**METROPOLITAN GOVERNMENT OF NASHVILLE AND DAVIDSON COUNTY**

**STAFF RECOMMENDATION**  
**1412 Sharpe Avenue**  
**June 18, 2014**

**Application:** New construction – infill and outbuilding  
**District:** Eastwood Neighborhood Conservation Zoning Overlay  
**Council District:** 06  
**Map and Parcel Number:** 08302011700  
**Applicant:** Jamie Pfeffer, Architect  
**Project Lead:** Sean Alexander, sean.alexander@nashville.gov

<p><b>Description of Project:</b> The applicant proposes to demolish a non-contributing structure and to construct a new house and detached garage.</p> <p><b>Recommendation Summary:</b> Staff recommends approval of the application to demolish the existing structure and to construct a new house and outbuilding with the conditions that:</p> <ol style="list-style-type: none"><li>1. Staff reviews the roof color, and the windows and doors for administrative approval;</li><li>2. Staff reviews the location of the HVAC for administrative approval.</li></ol> <p>Meeting those conditions, staff finds that the proposal will meet the applicable design guidelines for the Eastwood Neighborhood Conservation Zoning Overlay.</p>	<p><b>Attachments</b> <b>A:</b> Photographs <

1 SITE PLAN  
 SCALE 1/16" = 1'-0"

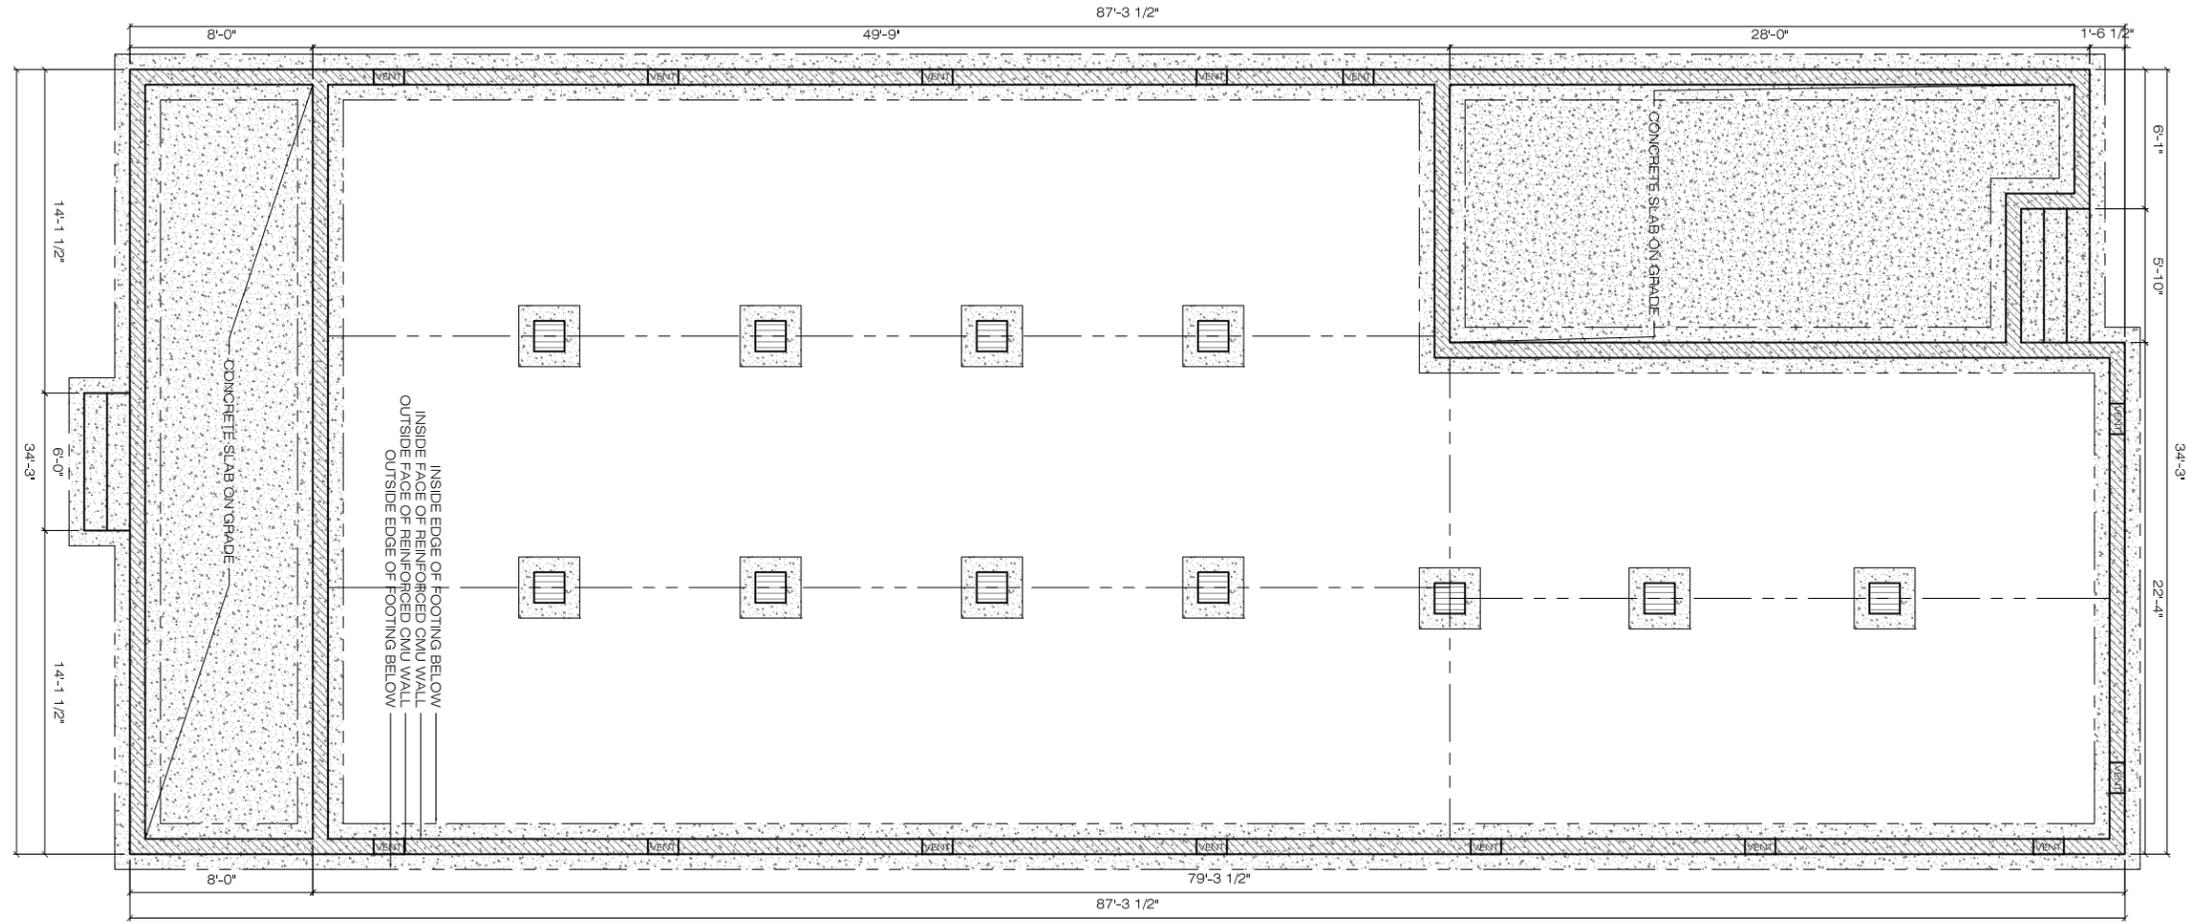
The new house will have a front setback of thirty-four feet, which is the average of the adjacent historic structures and is compatible with other historic houses nearby. The house will be shifted on the lot with a five foot (5') left side setback and an eleven foot (11') right setback. These setbacks are compatible with the surrounding context, where houses are generally shifted to one side to allow side-yard driveways because there is not alley at the rear.

Staff finds that the new building will be compatible with the setbacks and existing rhythm of spacing on the street, and that the project meets guideline II.B.1.c.

The new house will have an eight foot (8') deep full-width front porch, matching the orientation of surrounding historic houses. Because there is not an alley at the rear of the property, the house will be shifted to allow a driveway on the right side of the house. A walkway will connect from the porch to the driveway. Staff finds that the orientation matches surrounding historic houses and meets section II.B.1.f.

The new garage will be located behind the primary structure, accessed by a driveway from the street that will run along the right side of the house. This location is appropriate because it matches the surrounding context and there is not an alley at the rear. The building will be seventeen feet (17') tall with eaves at nine feet (9') above grade. The footprint will be less than seven-hundred square feet (<700 sf) in area. The materials will match those of the primary building: slab-on-grade concrete foundation, cement-fiber clapboard siding with cement-fiber board-and-batten in the gable field, and an asphalt shingle roof. More information is needed to review and administratively approve the garage doors.

A1.3

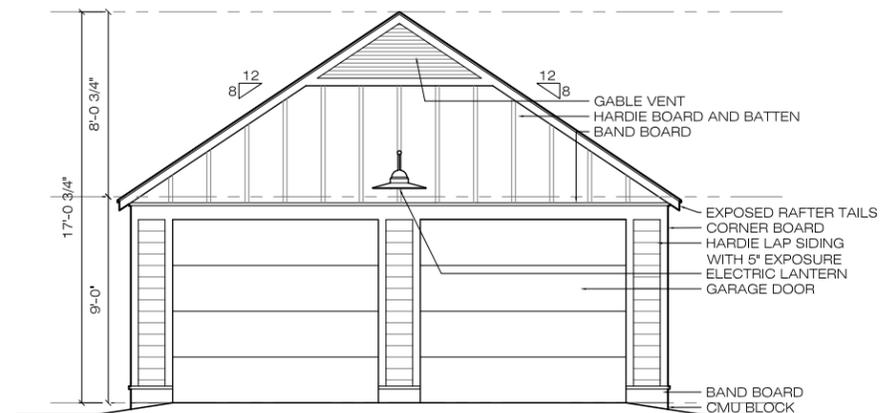
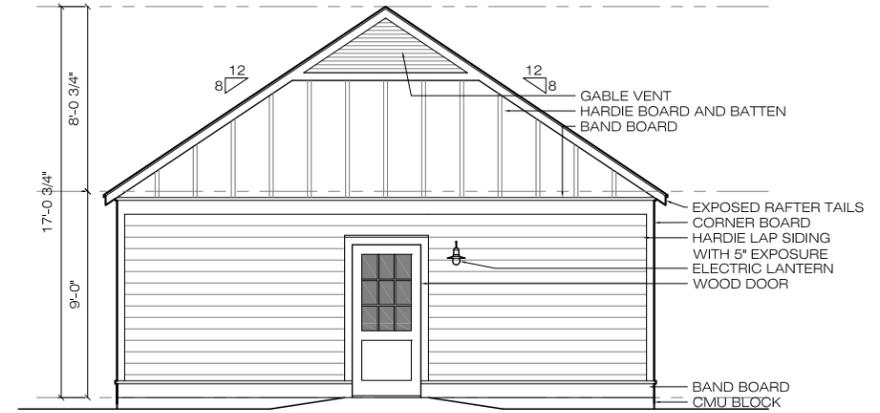
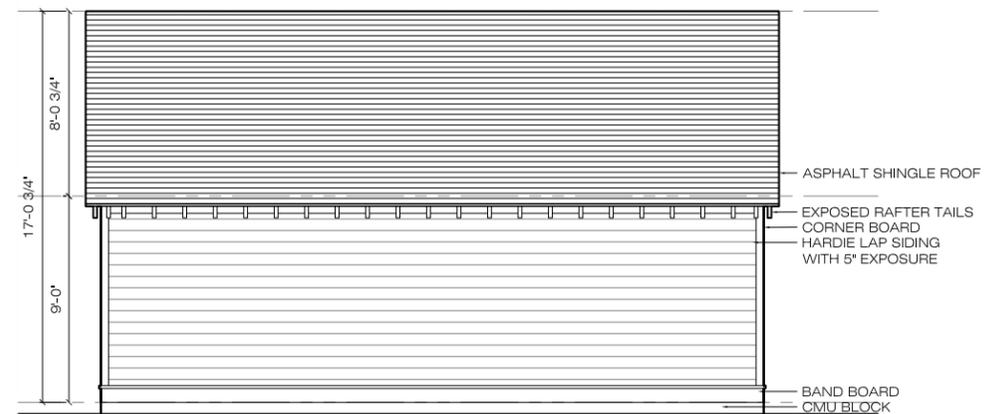
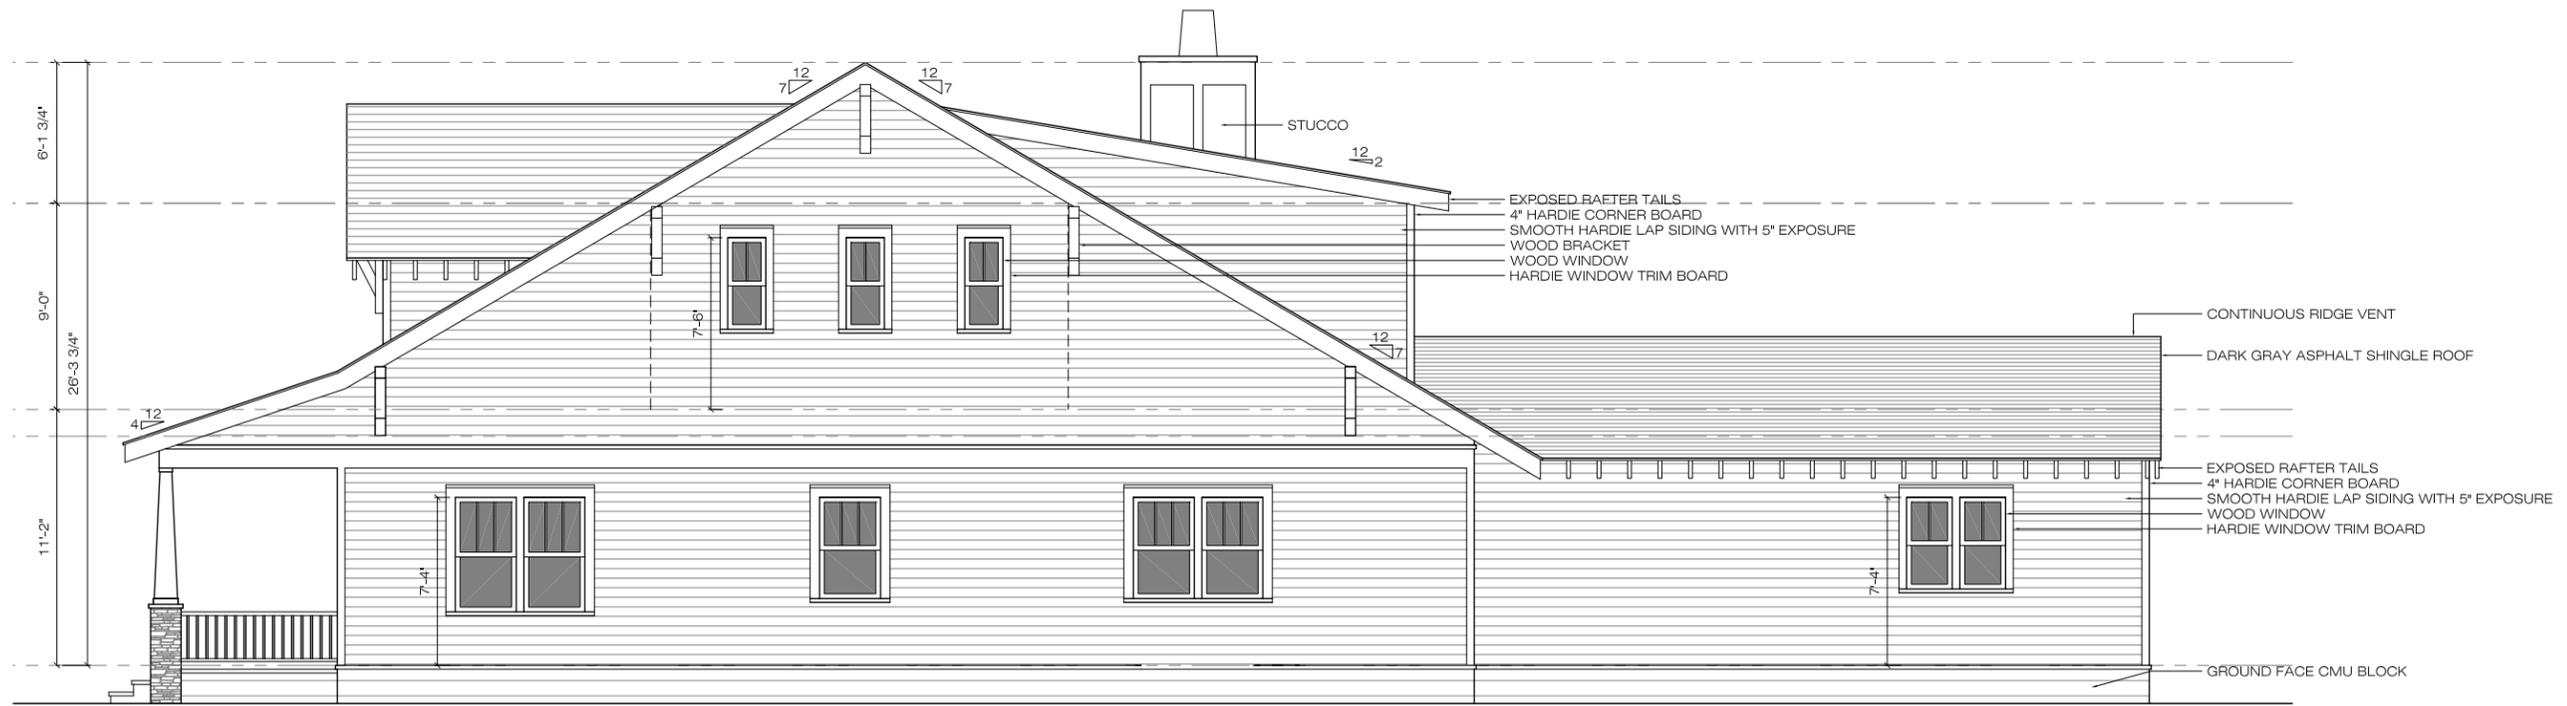
Staff finds the outbuilding will meet section II.B.1.h of the design guidelines.

1. Staff reviews the roof color, and the windows and doors for administrative approval;
2. Staff reviews the location of the HVAC for administrative approval.
